3.3.1.3 Oscillation Power Range Monitor (OPRM) Instrumentation

3.4 REACTOR COOLANT SYSTEM (RCS)

3.4.1 Recirculation Loops Operating

~~Figure 3.4.1-1~~

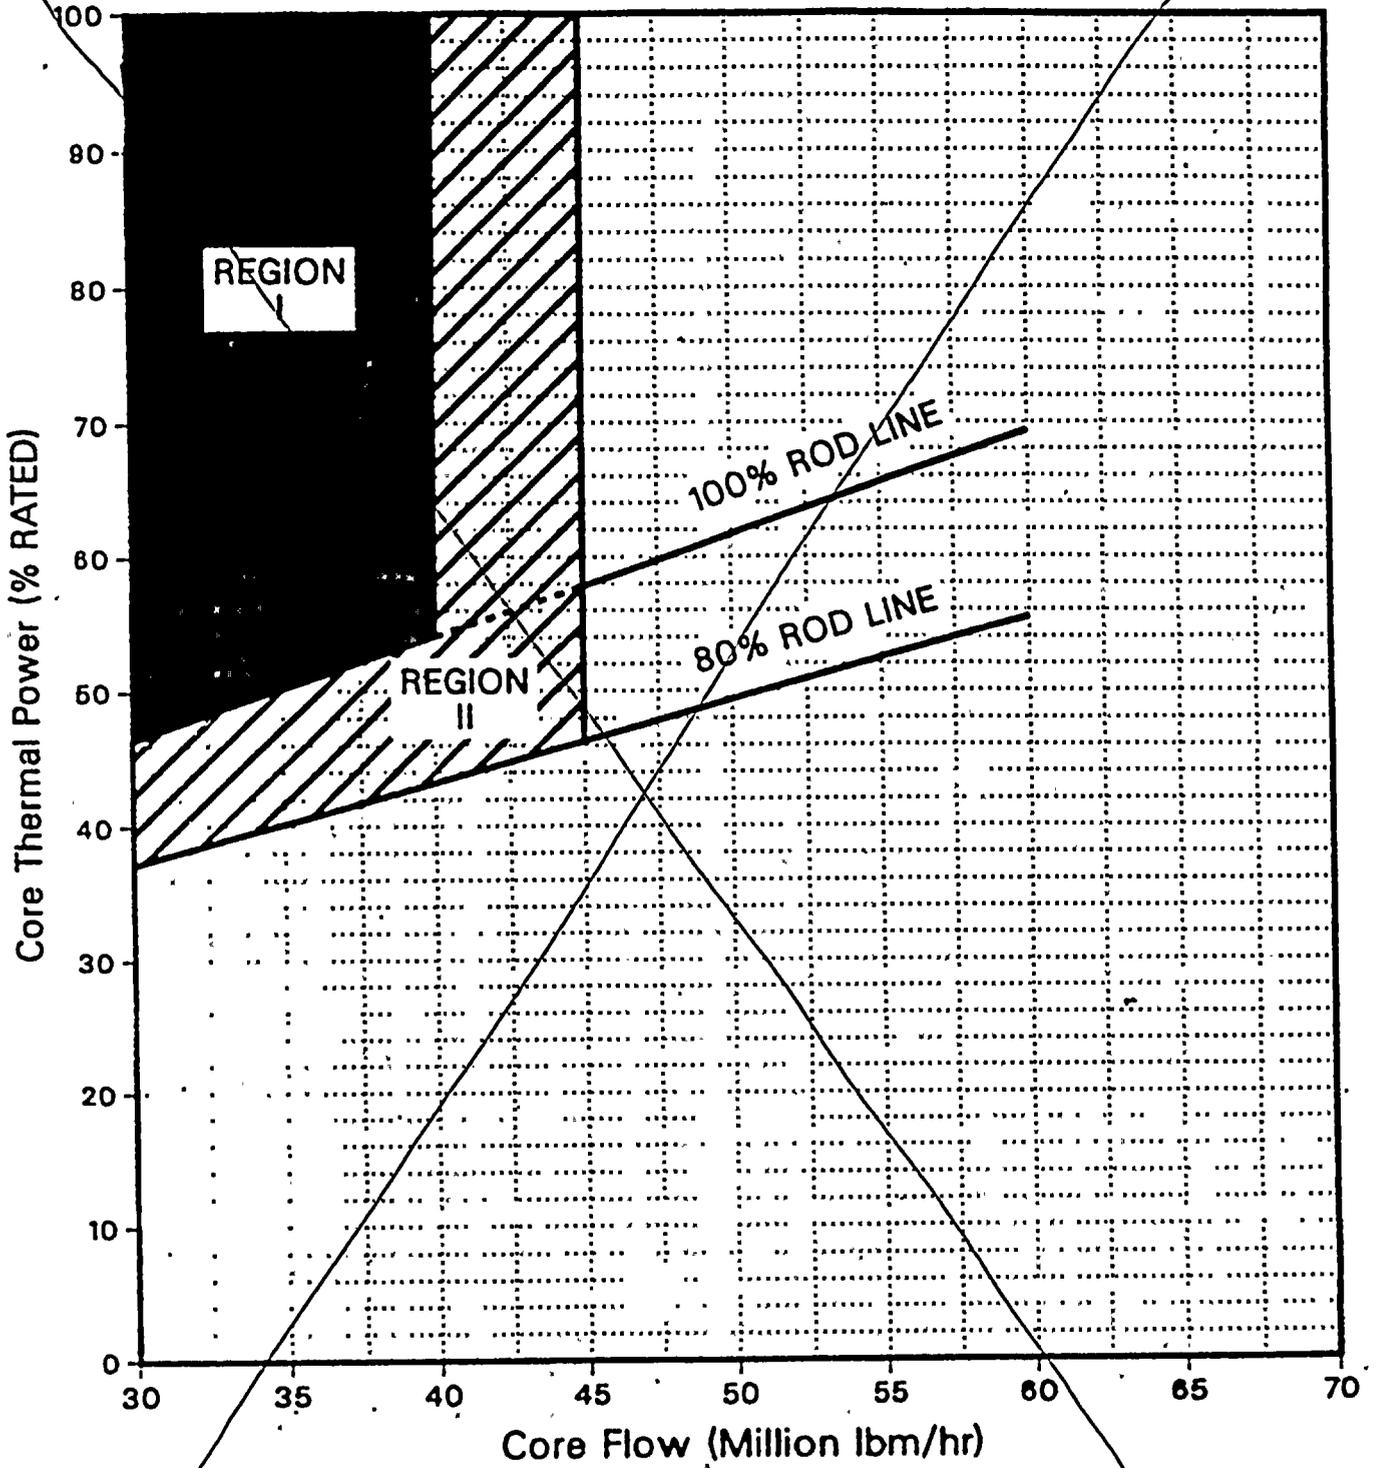
LCO 3.4.1 Two recirculation loops with matched flows shall be in operation ~~with a THERMAL POWER/core flow condition outside of Regions I and II of Figure 3.4.1-1.~~

One recirculation loop may be in operation provided the following limits are applied when the associated LCO is applicable ~~with a THERMAL POWER/core flow condition outside of Regions I and II of Figure 3.4.1-1.~~

CONDITION	REQUIRED ACTION	COMPLETION TIME
<p>A. <del>Total core flow as a function of THERMAL POWER within Region I of Figure 3.4.1-1.</del></p> <p><del>OR</del></p> <p>No recirculation loops operating while in MODE 1</p>	<p>A.1 Place reactor mode switch in the shutdown position.</p>	<p>Immediately</p>
<p><del>B. -----NOTE----- Only applicable when in Region II of Figure 3.4.1-1 -----</del></p> <p><del>Two or more APRM readings oscillating with one or more oscillating <math>\geq 10\%</math> of RTP peak-to-peak.</del></p> <p><del>OR</del></p> <p><del>Two or more LPRM upscale alarms activating and deactivating with a period <math>\geq 1</math> second and <math>\leq 5</math> seconds.</del></p> <p><del>OR</del></p> <p><del>Sustained LPRM oscillations <math>&gt; 10</math> w/cm<sup>2</sup> peak-to-peak with a period <math>\geq 1</math> second and <math>\leq 5</math> seconds.</del></p> <p><del>OR</del></p>	<p><del>B.1 Place the reactor mode switch in the shutdown position.</del></p>	<p>Immediately</p> <p style="text-align: right;"><del>(continued)</del></p>

CONDITION	REQUIRED ACTION	COMPLETION TIME
<del>B.</del> (continued)  <del>Less than 50% of required LPRM upscale alarms OPERABLE</del>		
<del>C.</del> Total core flow as a function of THERMAL POWER within Region II of Figure 3.4.1-1	<del>C.1</del> Initiate action to restore total core flow as a function of THERMAL POWER outside of Region II.	Immediately
B <del>D.</del> Recirculation loop flow mismatch not within limits.	B D.1 Declare the recirculation loop with lower flow to be "not in operation."	2 hours
C <del>E.</del> No recirculation loops in operation while in MODE 2  <u>OR</u>  Single Recirculation Loop required limits and setpoints not established within required time.	C E.1 Be in MODE 3.	12 hours

~~In addition, during two-loop and single-loop operation, the combination of core flow and THERMAL POWER must be outside of LCO Region I or II of Figure 3.4.1-1 to limit the impact of core thermal hydraulic oscillations. The plant is operated in conformance with the recommendations in NRC Bulletin 88-07, Supplement 1, (Ref. 4). These operating restrictions provide a high degree of confidence that reactor instabilities will not occur or will not be of sufficient severity to violate the MCPR safety limit.~~

~~This SR ensures the combination of core flow and THERMAL POWER are within required limits to prevent uncontrolled thermal hydraulic oscillations by ensuring the recirculation loops are within the limits established by Figure 3.4.1-1. At low recirculation flows and high reactor power,~~

Although this transient is protected for expected modes of oscillation by the OPRM system, when operable per LCO 3.3.1.3 (References 3 and 4), the prudent response to the natural circulation condition is to preclude potential thermal-hydraulic oscillations by immediately placing the mode switch in the shutdown position.
